**CITY OF AVON LAKE  
PLANNING COMMISSION  
150 Avon Belden Road  
Avon Lake, Ohio 44012  
(440) 930-4110**

**AGENDA  
Tuesday, June 3, 2025  
7:00 PM  
City Council Chambers**

**Re:** Case No. CPC-24-18, MDC Ventures LLC, Site Plan Approval for the Construction of a New Corporate Office at 32870 Pin Oak Parkway.

Reference: Improvement Plans for Proposed Tomshack Building  
32870 Pin Oak Parkway

FLOOR PLAN  
SCALE: 3/16" = 1'-0" TOTAL AREA: 8,335 SQ. FT.

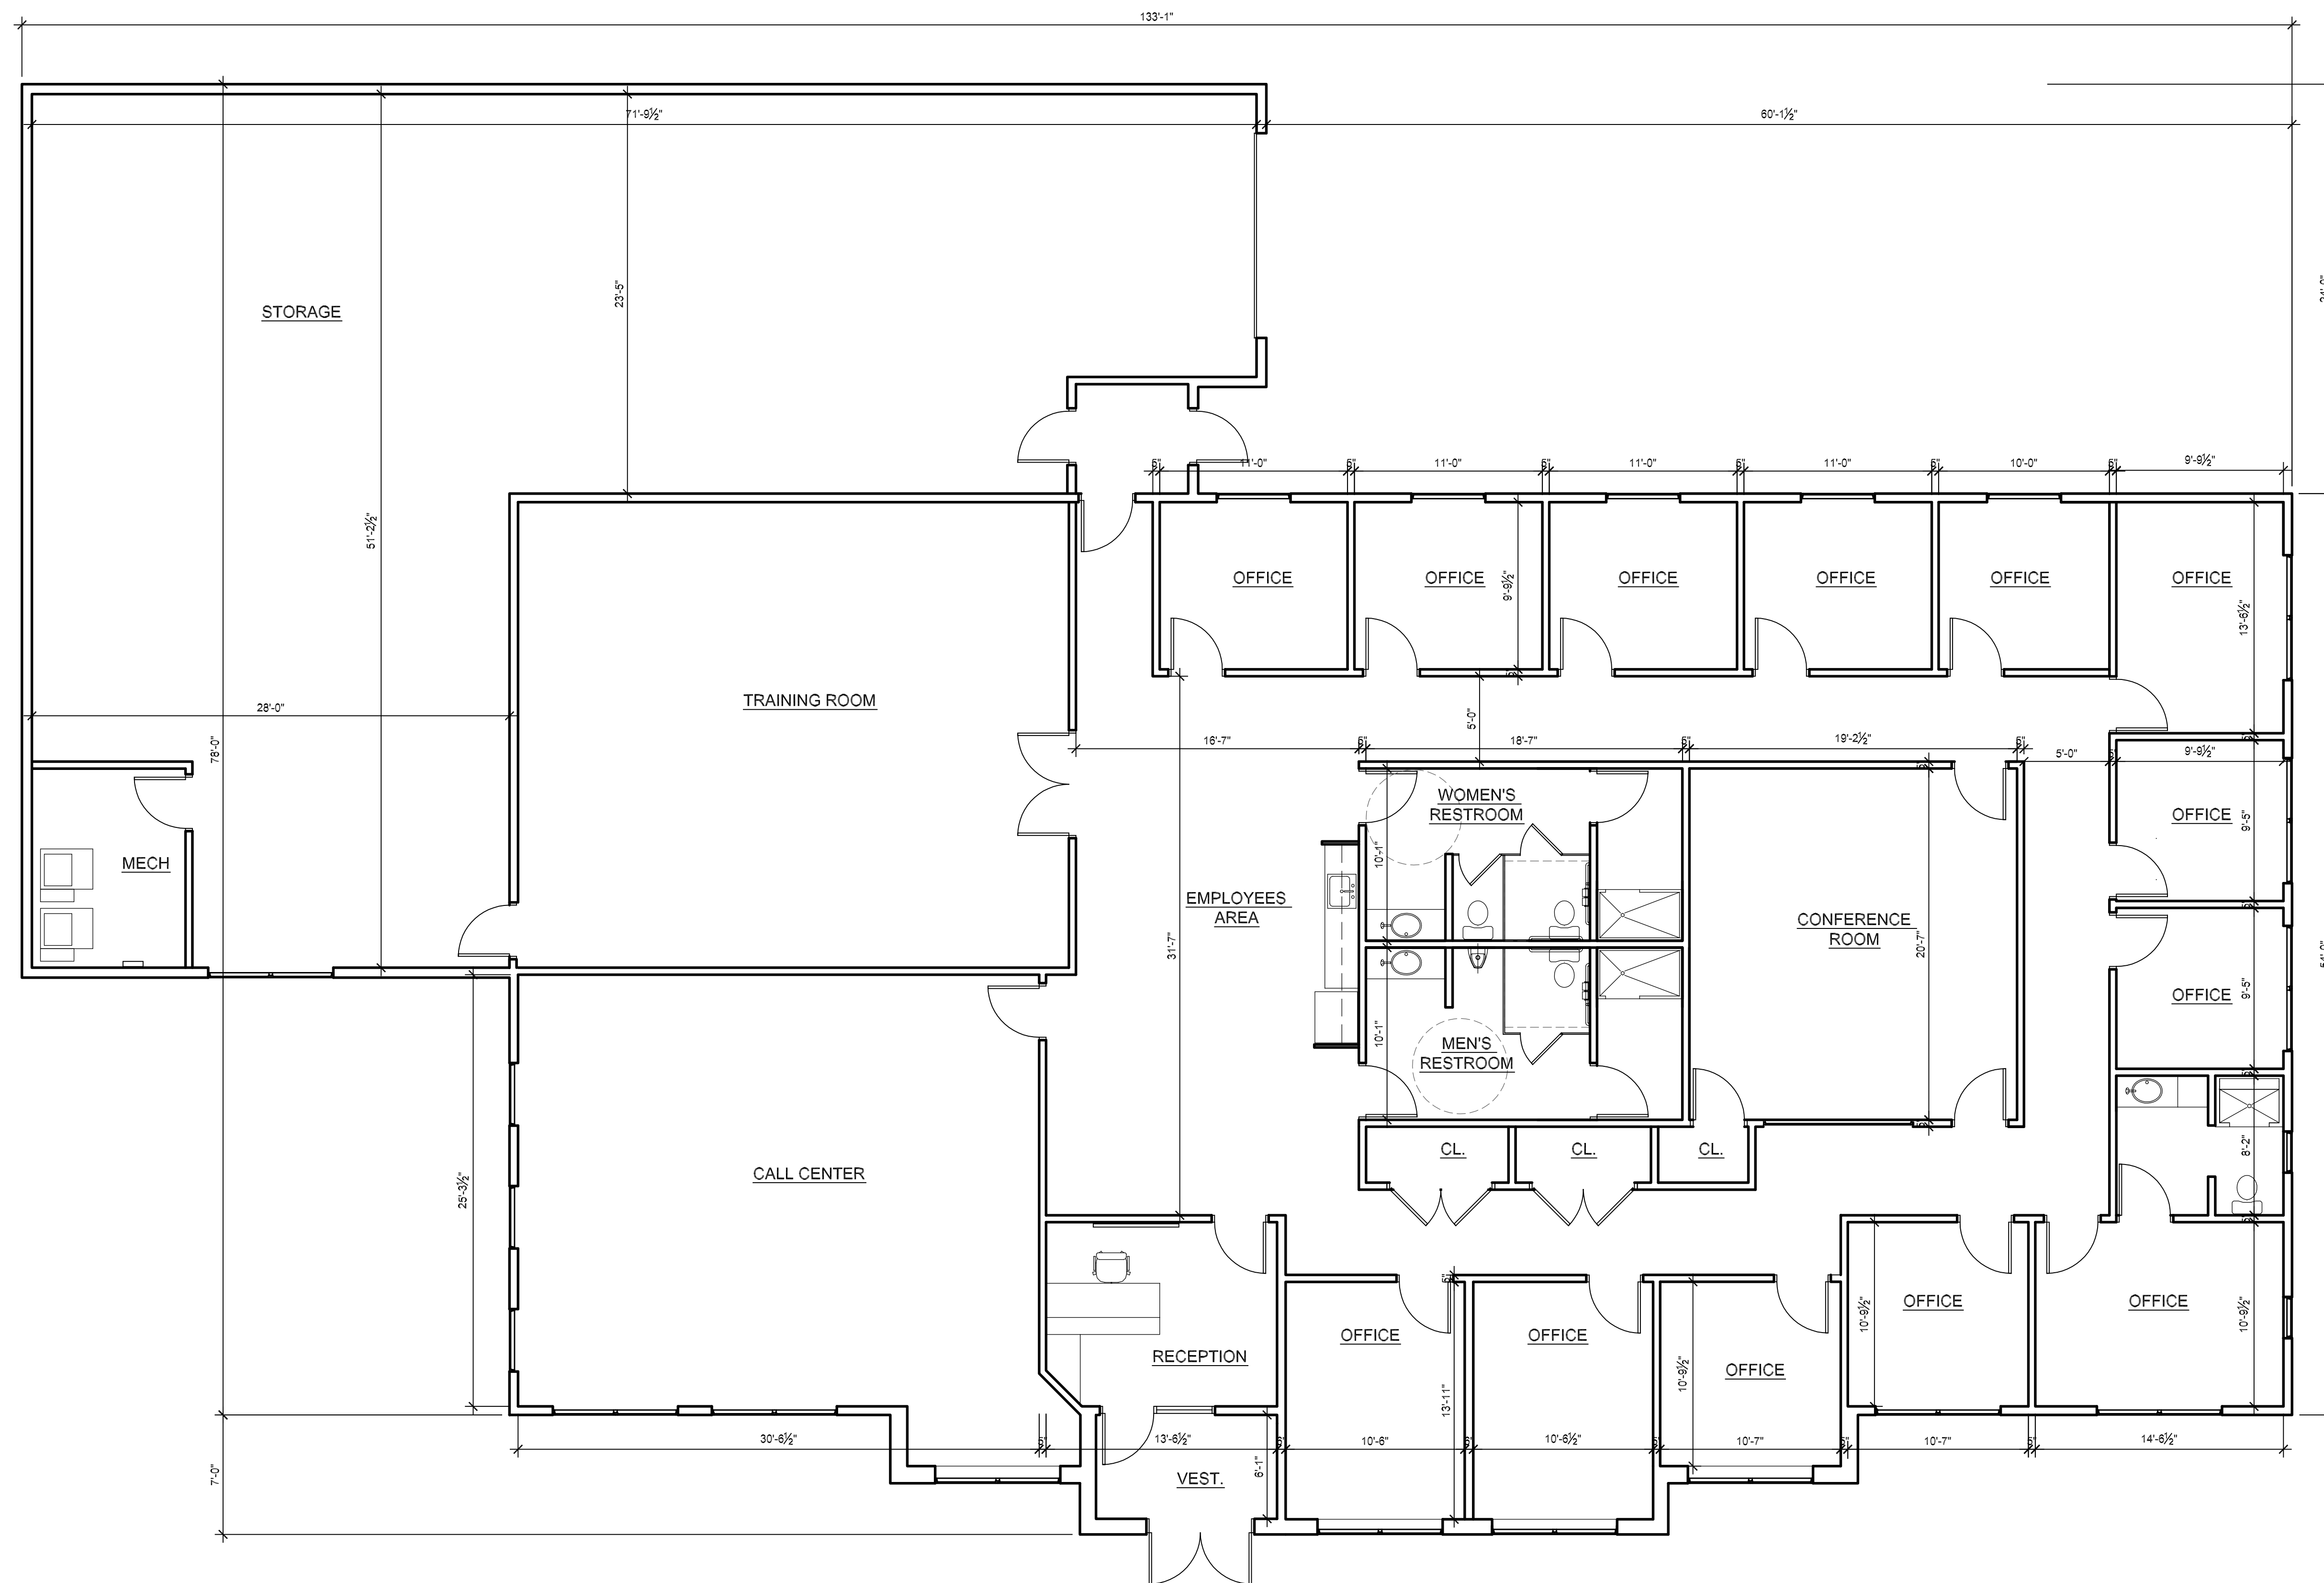
**Note:** Staff identified a minor discrepancy between the architectural and engineering drawings related to building square footage and parking count. The architectural plans list the building at 8,535 square feet with 25 parking spaces, while the engineering drawings reflect a slightly smaller footprint with 26 spaces. This difference does not materially affect the project's zoning compliance, but the applicant should clarify which plan is final and ensure consistency before permit issuance.
